NEW DIVER 6

WHAT CHANGES

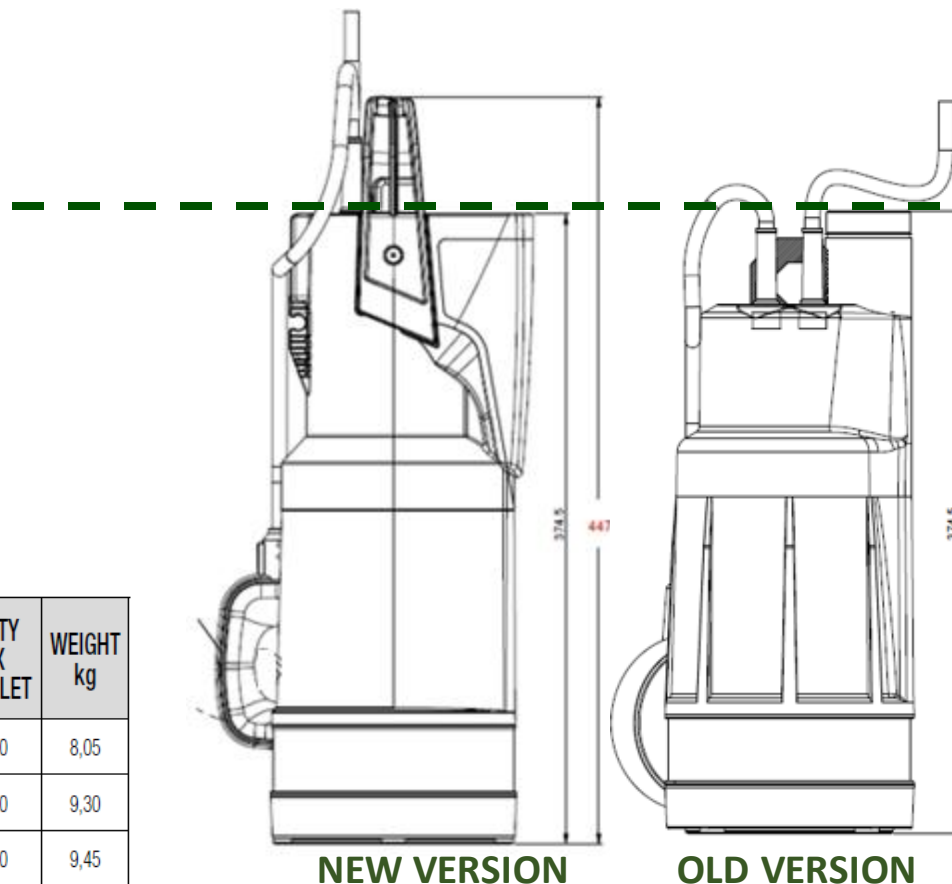
✓ Improved Aesthetic

A comfortable handle makes situations of unpacking and installation of the pump simpler.
